# **Comment** **I-93 – TX BEACON Loopback Lockup**

IEEE 802.3da - September 2025 Interim – Minneapolis, MN

148.4.7.5 D-PLCA Control state diagram  
plca\_reset + (!dplca\_en) + (!plca\_en)

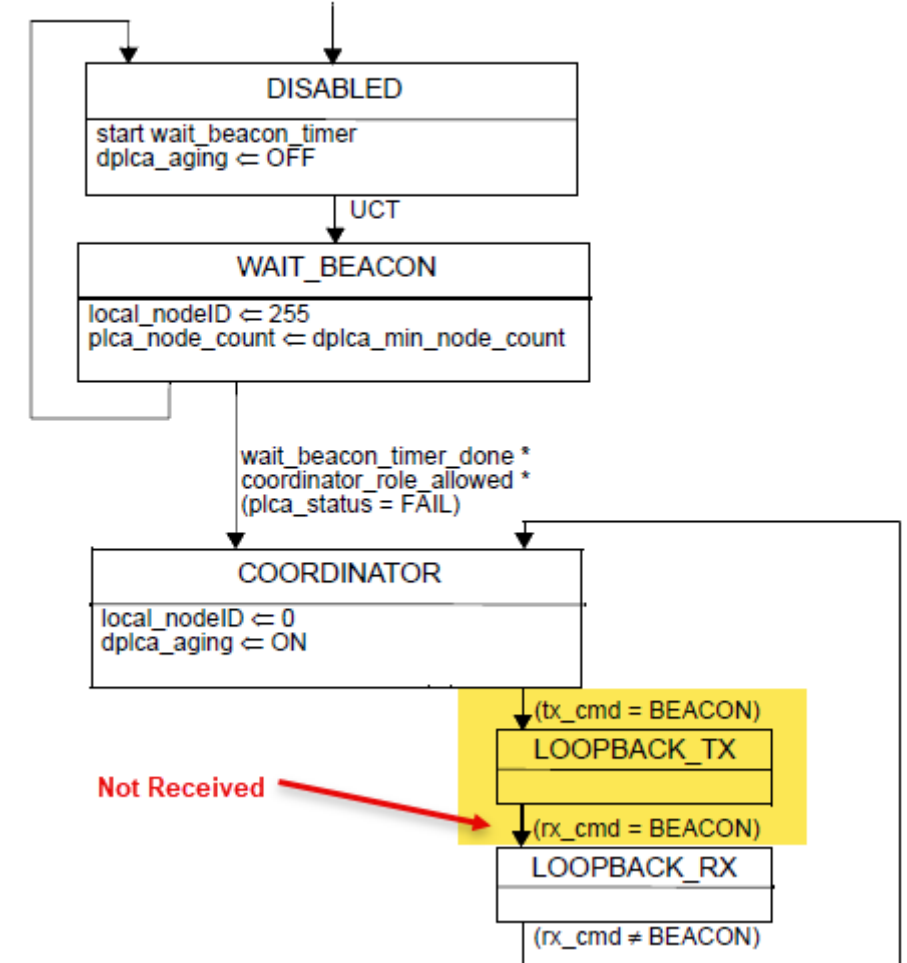
- Current D-PLCA Control State Diagram can remain stuck in LOOPBACK\_TX state if the locally transmitted BEACON is not detected due to noise or interference
- Credit to Pablo Ventura (ADI) for identifying this corner case

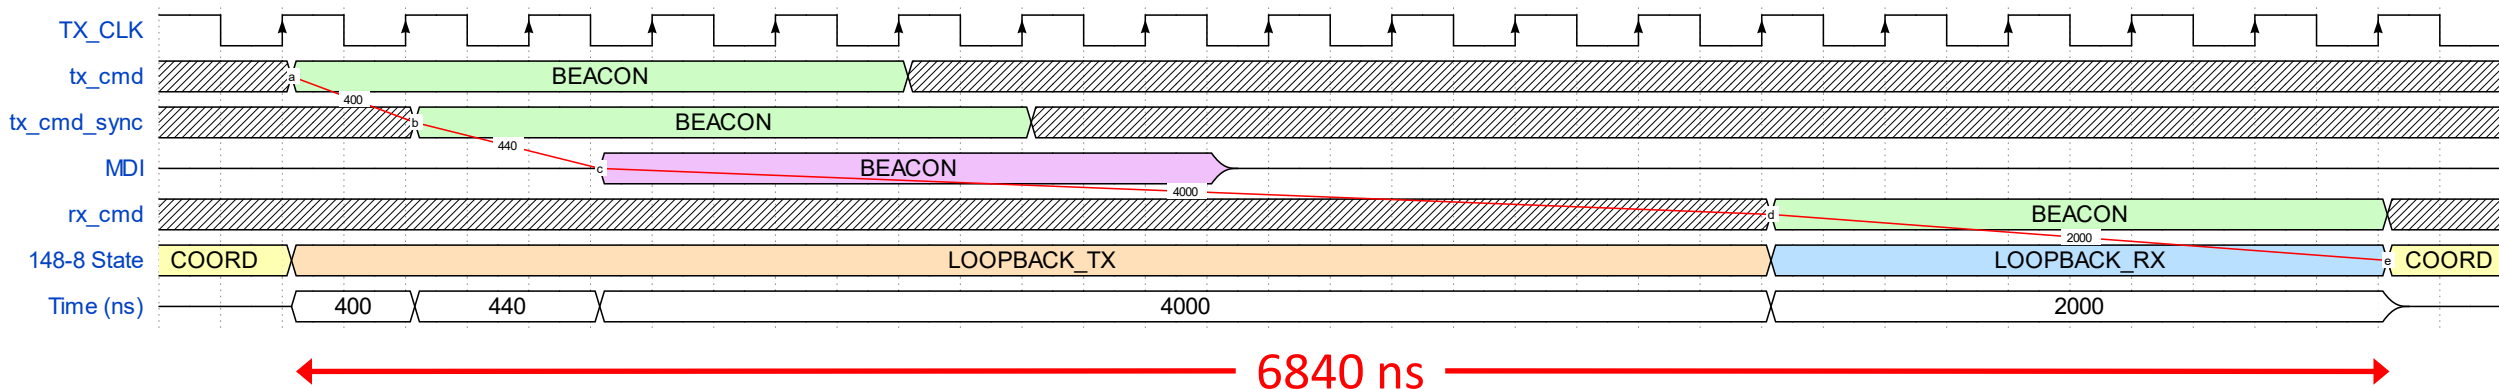
- Add a timer to limit how long the state diagram can remain in LOOPBACK\_TX
- How long should the timer be?
  - Slide 7 [https://www.ieee802.org/3/da/public/0525/Baggett\\_3da\\_Cmt47\\_DPLCA\\_Block\\_Own\\_BEACONS\\_v01.pdf](https://www.ieee802.org/3/da/public/0525/Baggett_3da_Cmt47_DPLCA_Block_Own_BEACONS_v01.pdf)
  - 6.9  $\mu$ s using PHY delay constraints in Tables 147-6 and 188-5
    - Time from setting tx\_cmd=BEACON to last possible time to receive rx\_cmd=BEACOM

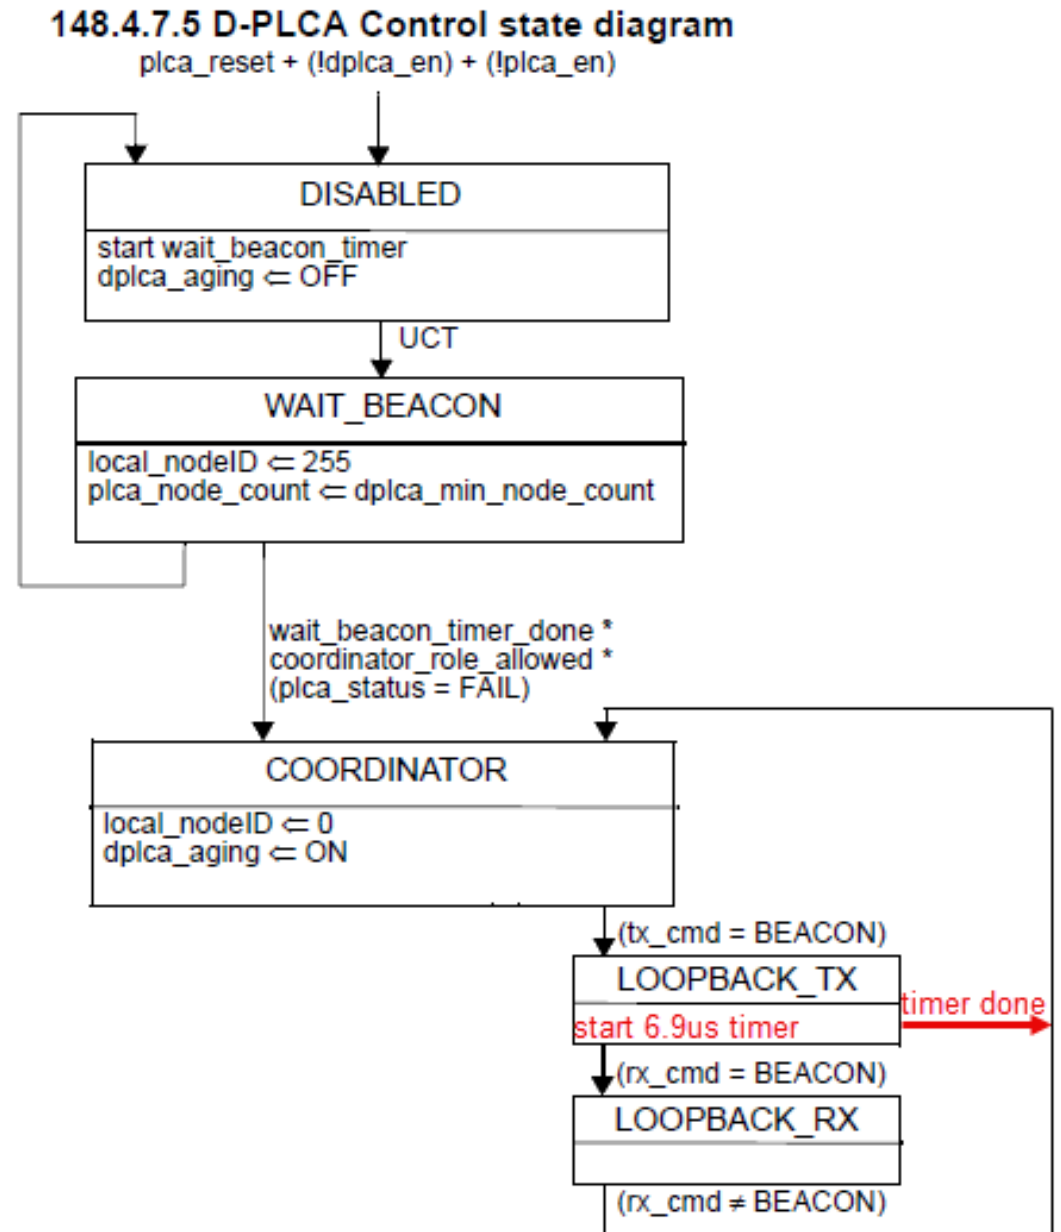
- Start 6.9  $\mu$ s timer on entry to LOOPBACK\_TX
- Exit LOOPBACK\_TX back to COORDINATOR on timer done

## P82 L24 Figure 148-8 – D-PLCA Control State Diagram

- **Inside LOOPBACK\_TX state add the action**  
start beacon\_timeout\_timer
- **Add transition from LOOPBACK\_TX to COORDINATOR with condition**  
beacon\_timeout\_timer done
